CITY OF ALBUQUERQUE

Re: 2900 Central Project 2900 Central Ave. SE

Traffic Circulation Layout

The TCL submittal received 02-05-2024 is approved for Building Permit by Transportation. A copy of the stamped and signed plan will be needed for each of the building permit plans. Please keep the original to be used for certification of the site for final C.O. for Transportation.

TCL2

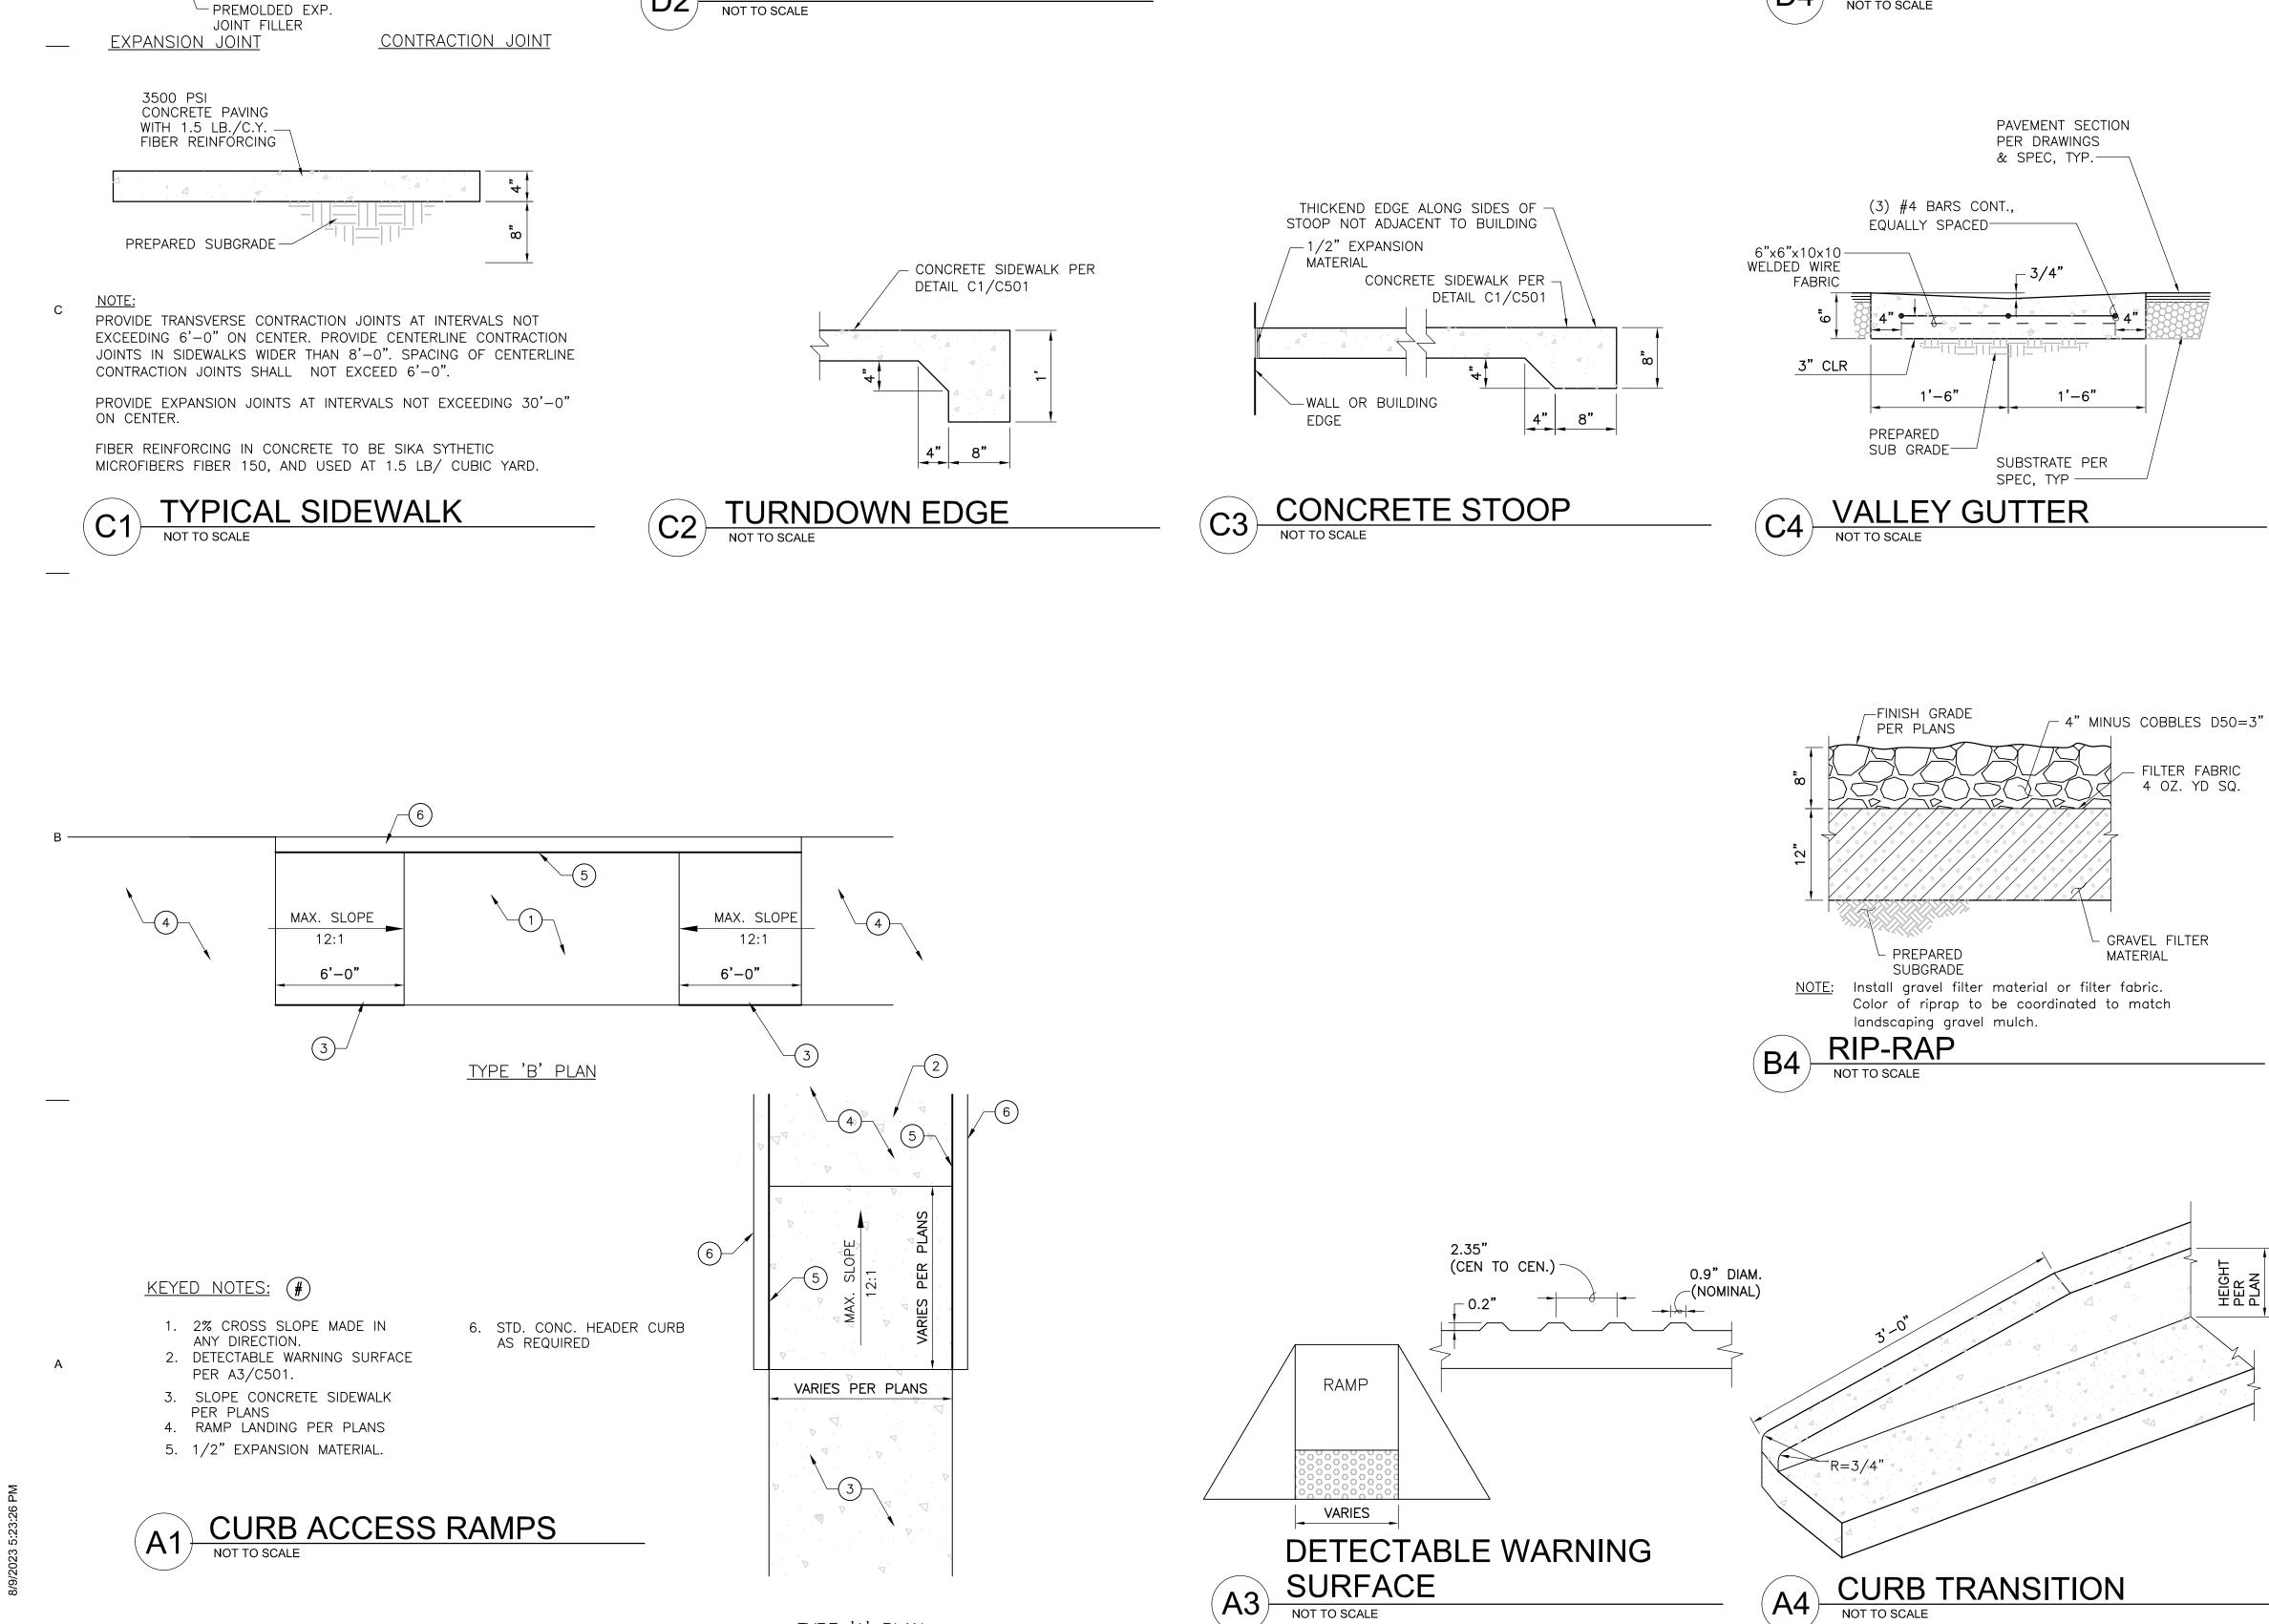
When the site construction is completed and an inspection for Certificate of Occupancy (C.O.) is requested, use the original City stamped approved TCL for certification. Redline any minor changes and adjustments that were made in the field. A NM registered architect or engineer must stamp, sign, and date the certification TCL along with indicating that the development was built in "substantial compliance" with the TCL. Submit this certification, the TCL, and a completed <u>Drainage and Transportation Information Sheet</u> to front counter personnel for log in and evaluation by Transportation. **CONDITION FOR RELEASING THE FINAL CO: AN APPROVED REVOCABLE PERMIT FOR THE EXISTING SIGN (KEYNOTE 35).**
